UNITED STATES  
NUCLEAR REGULATORY COMMISSION

SUBJECT: ISSUANCE OF AMENDMENTS - CATAWBA NUCLEAR STATION, UNITS 1 AND 2  
REDUCTION IN REACTOR COOLANT SYSTEM FLOW RATE FOR UNIT 1  
(TAC NOS. M88058 AND M88059)

Amendment No. 113  
License No. NPF-35

Amendment No. 107  
License No. NPF-52

Figure 2.1-1a  
REACTOR CORE SAFETY LIMITS - FOUR LOOPS IN OPERATION  
382,000 gpm

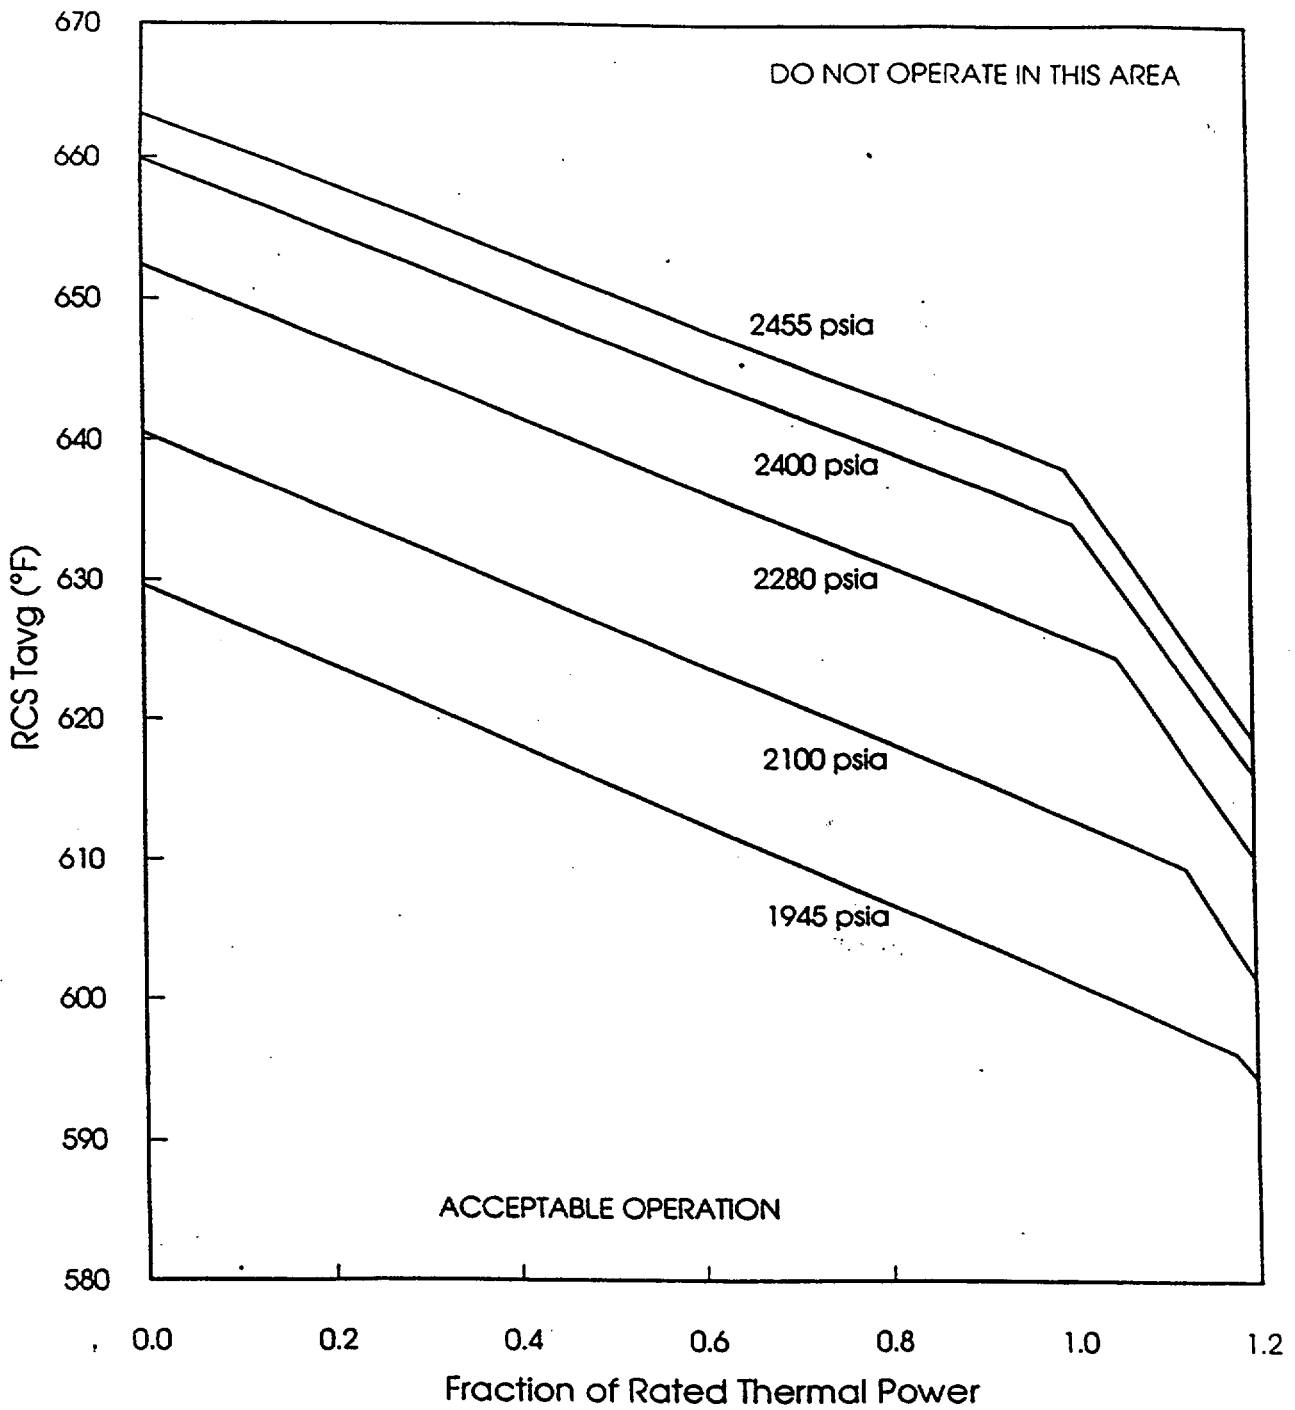
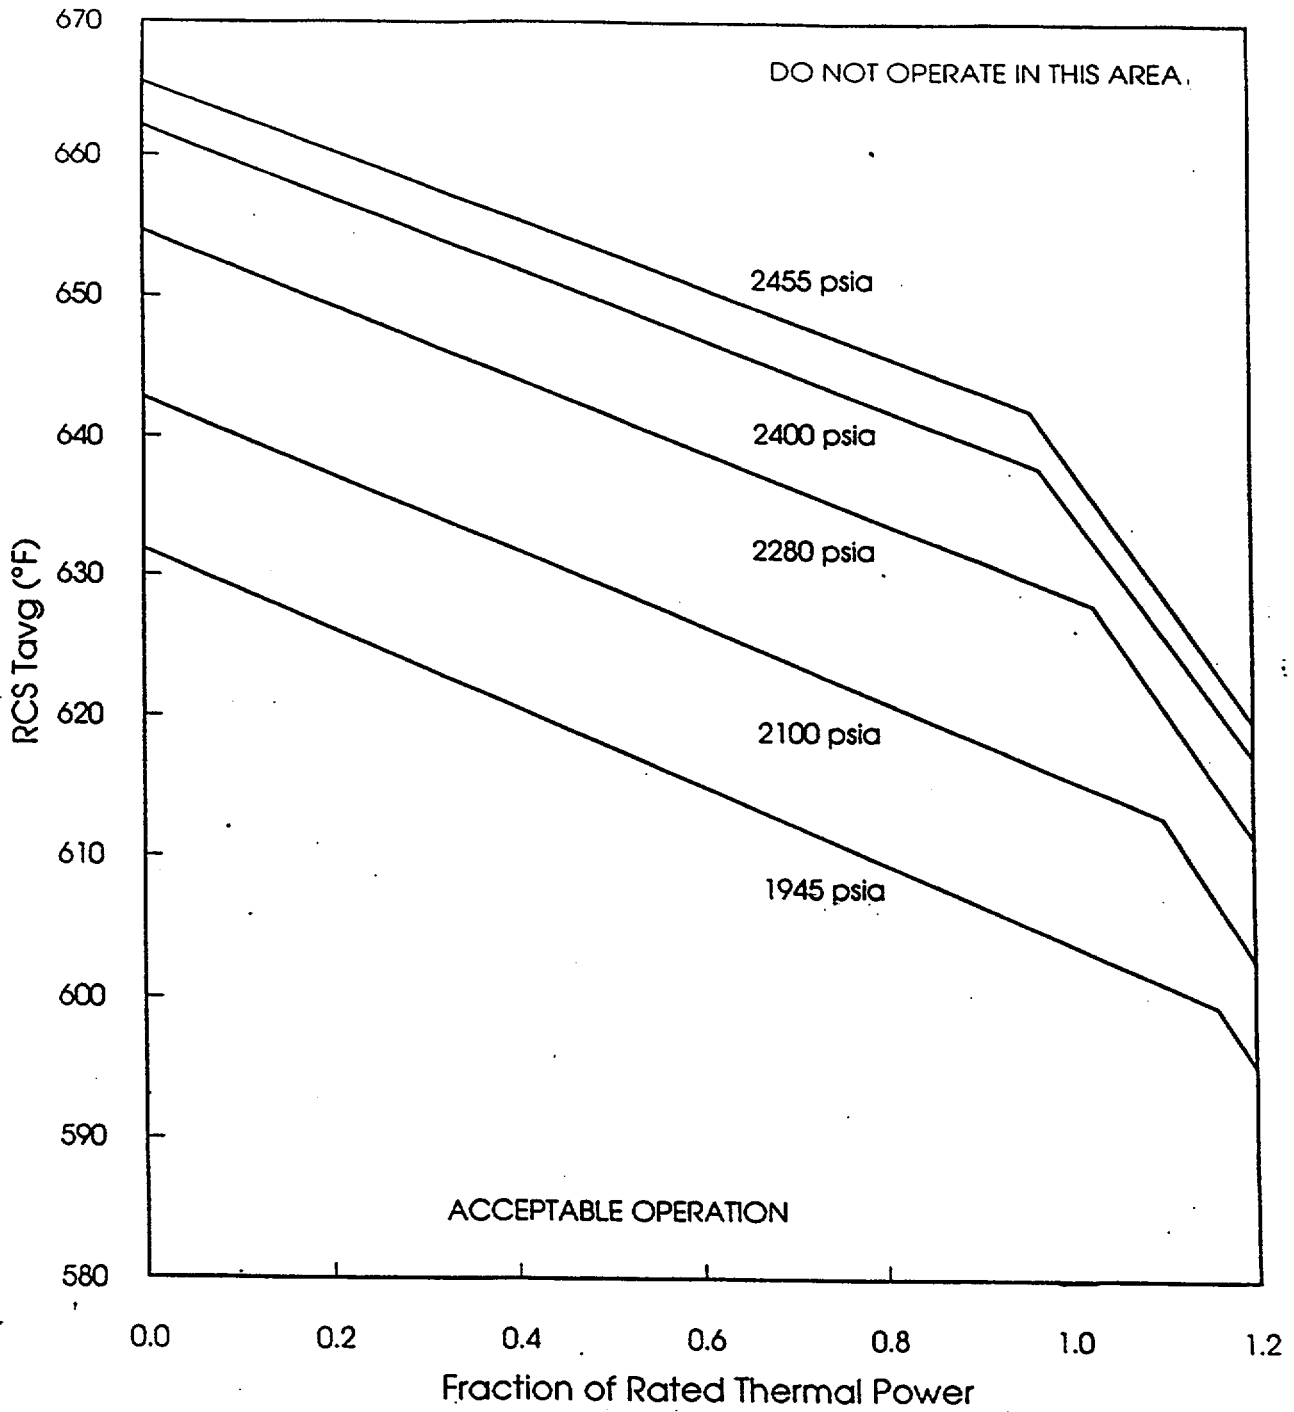
The amendments revise TS Figure 2.1-1, certain TS Table 2.2-1 factors in the equation for the OVERTEMPERATURE  $\Delta T$  and OVERPOWER  $\Delta T$  setpoints, and TS Figure 3.2-1 to reflect a reduction in the required minimum measured reactor coolant system (RCS) flow rate from 385,000 gallons per minute (gpm) to 382,000 gpm for Unit 1. Catawba Unit 2 values are unchanged and, accordingly, certain TS pages are modified to retain the current TS values in effect for Unit 2. The need for the change is attributed to the effects of steam generator tube plugging and to a hot leg temperature streaming phenomenon. The application also proposed to revise the text of TS 2.1.1 and definition for TS Figure 2.1-1. These changes are not related to the changes in RCS flow rate. The staff is continuing to review these proposed changes and, accordingly, they are not dealt with in this amendment.
